NTUA Headquarters Complex Office Building

Dyron Murphy Architects Project No. 2015.05

ADDENDUM No. 2

November 4, 2016

PAC-2000F COLUMN COVERS

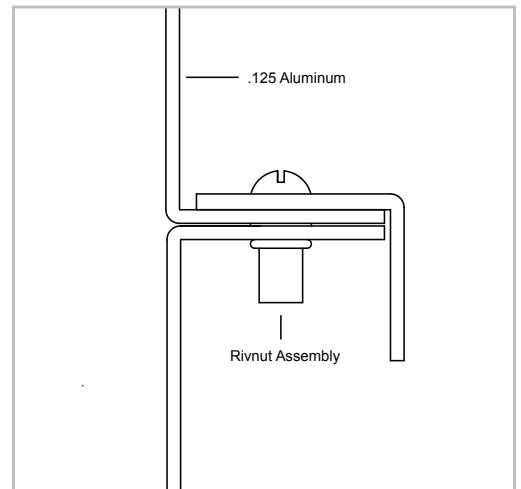
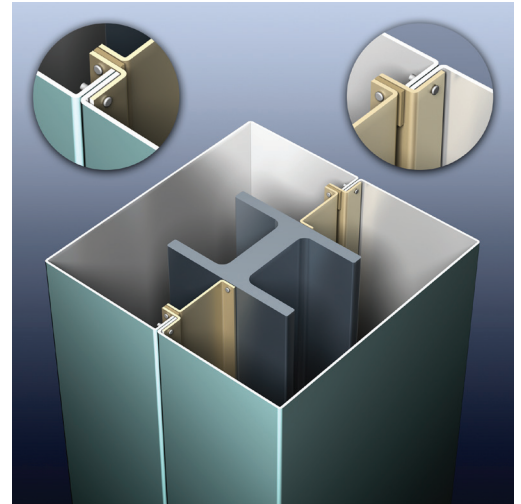
10. Specs for the Column Cladding calls for Petersen, Pac-Clad PAC-2000F. The Floor Plans indicate locations. I have not seen any elevations of the various column wraps, nor details for them. There appears to be both square wraps and rectangular wraps, but no sizes are given. Nor am I able to determine heights required, other than to go by RCP heights at the various rooms. Is there a column cladding schedule available? Or details showing overall depths, widths, and heights?

Column covers are to be installed and details are per manufacturer. Refer to attached manufacturer detail. Heights of the column covers are to be 6" above the finished ceiling. Refer to the ceiling plan for heights required at each location. Widths are to be provided per manufacturer standard sizes required to conceal the column at each location.

C101
Sequence of

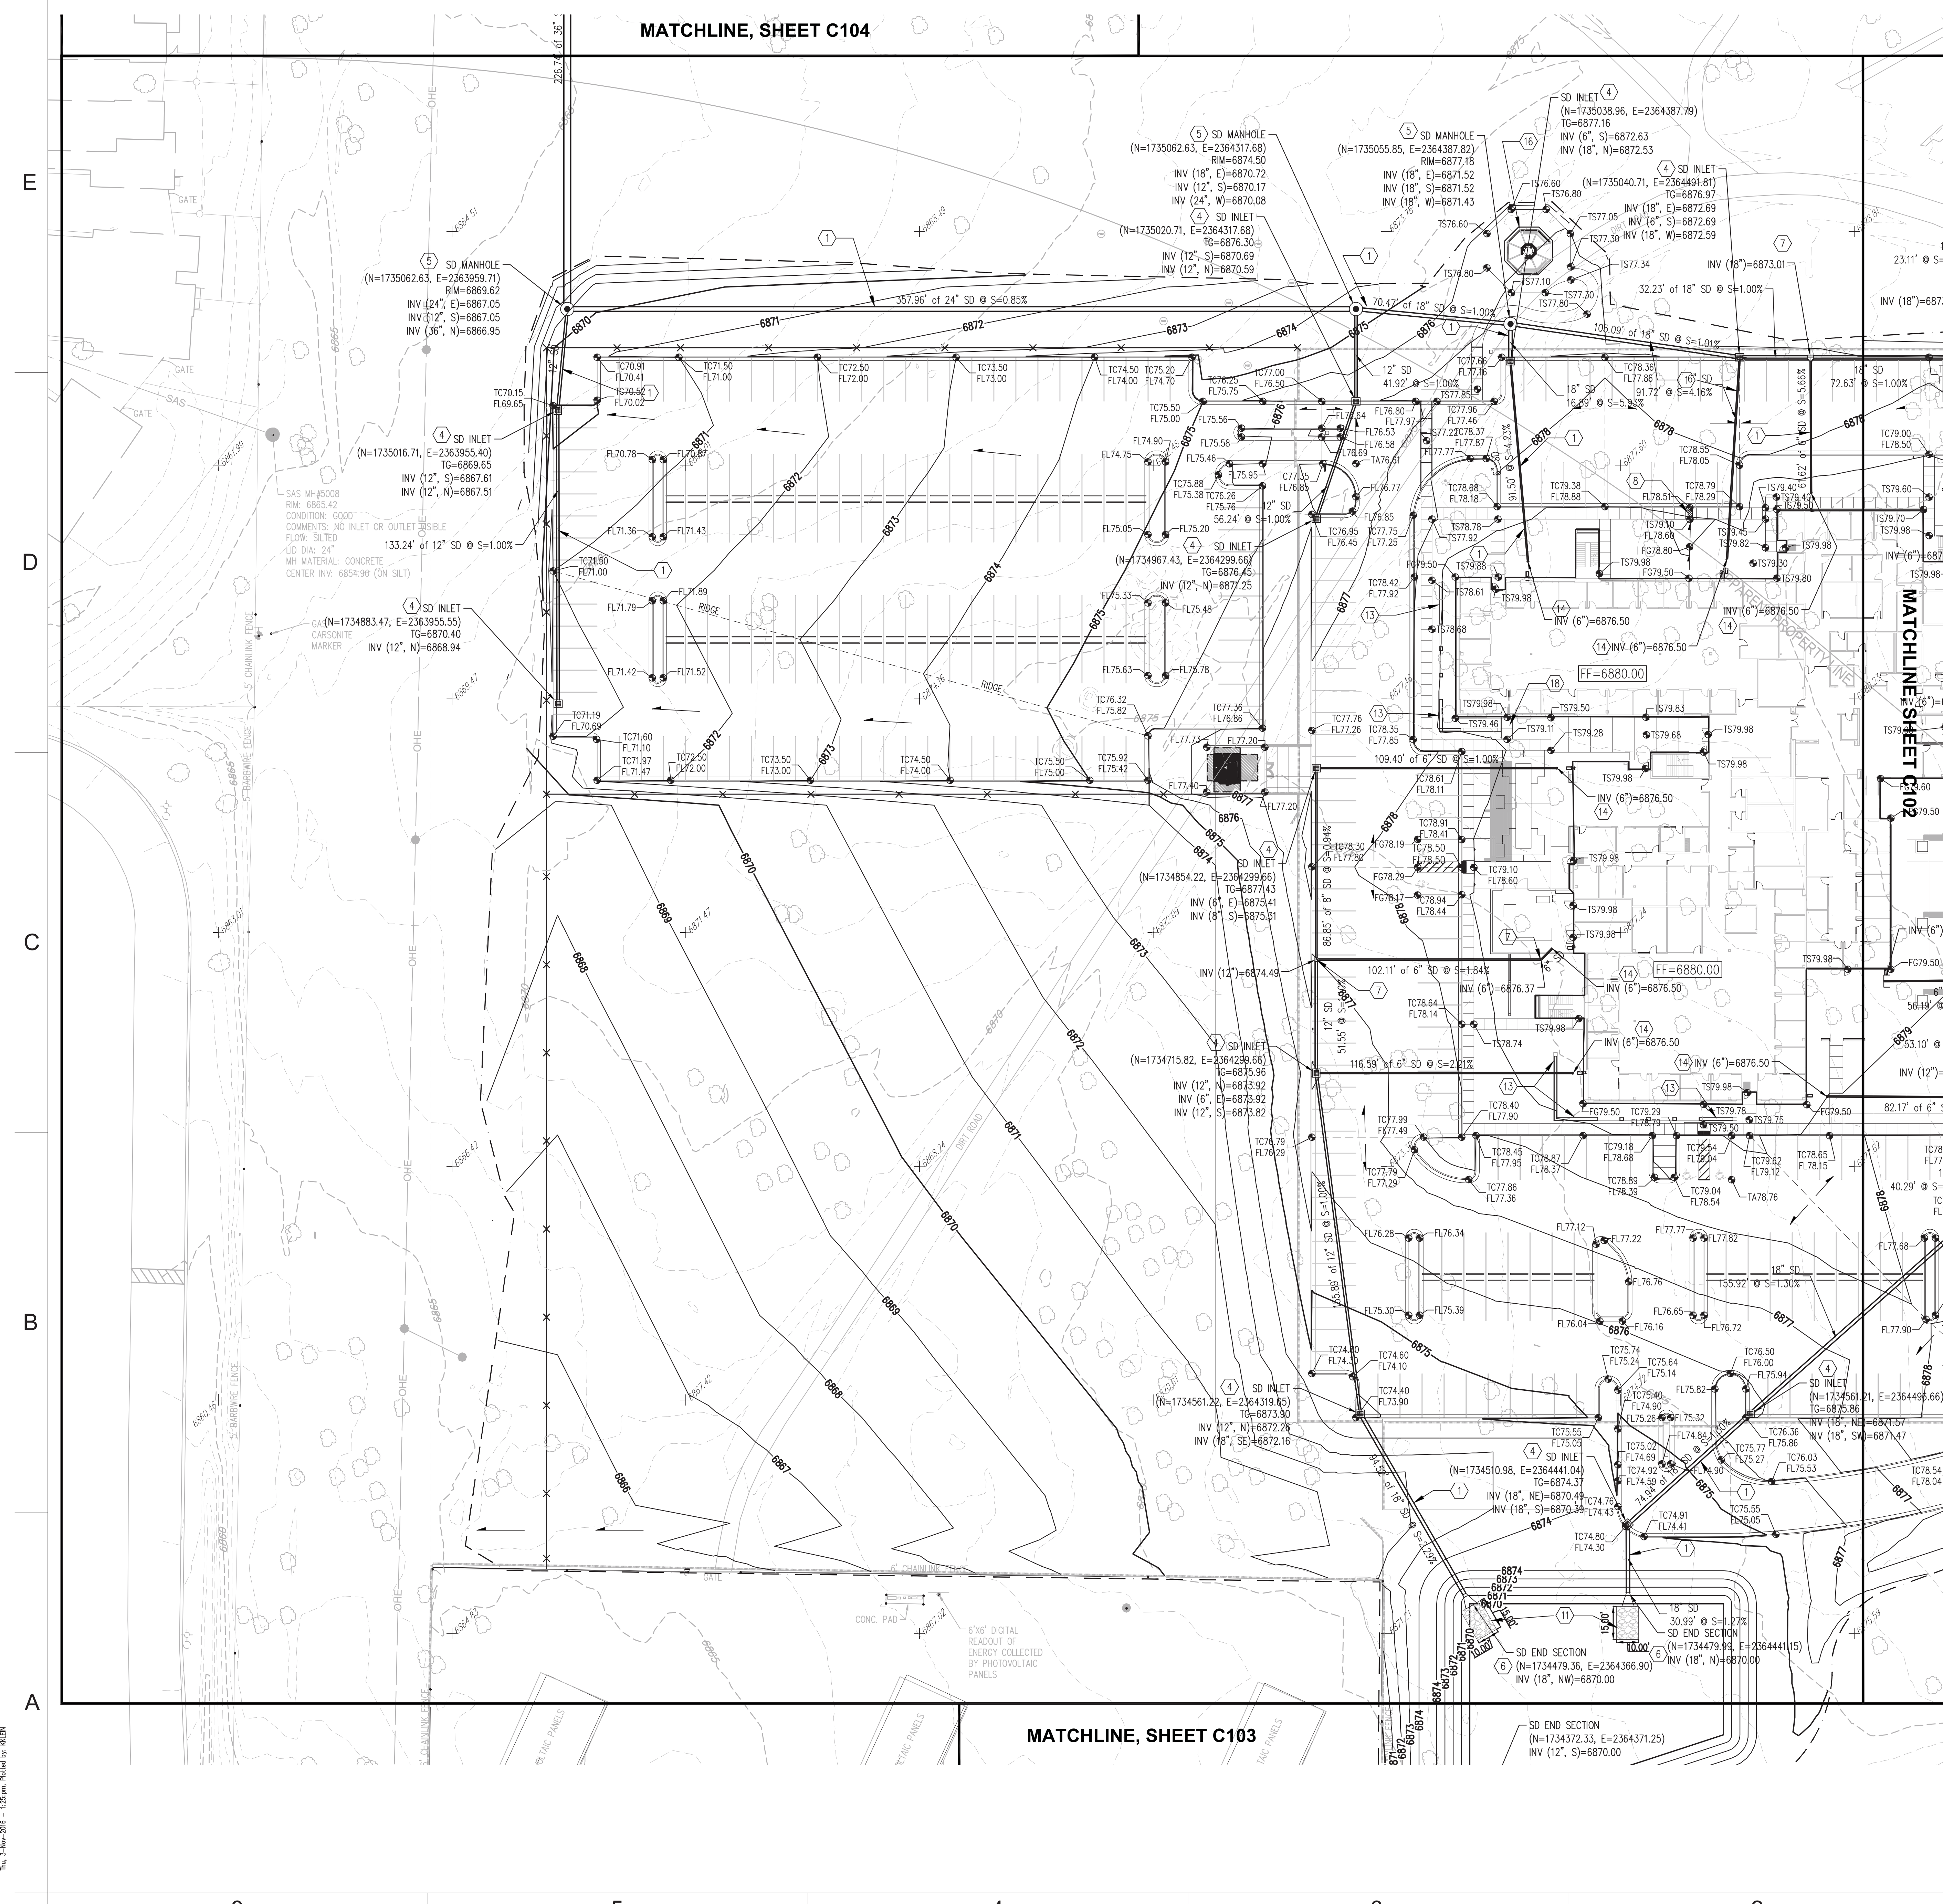
1. C101 There is a storm drain inlet that is not traffic rated, but is in the parking lot. Junction of 6” roof drain line and 8” SD.
Response: The Keyed note has been changed from 2 to 4 to indicate that the inlet is to be traffic rated. (Refer to revised Sheet C101, Addendum 02).
2. C104 Match line, Above Left drawing has note 15 pointing to what appears to be flat work at the detention pond. Note 15 indicates it is a 24” inlet with pedestrian rated grate. Please clarify.
Response: Note 15 has been changed to note 12 and the overflow drainage structure has been relocated (Refer to revised Sheet C104, Addendum 02).
3. C202 keynote 20 indicates valves are to be installed on a 12” water main that is “proposed by others”. Please verify that the valves will not be included with the “others” installation.
Response: Confirmed, the valve will not be included with the “others” installation.
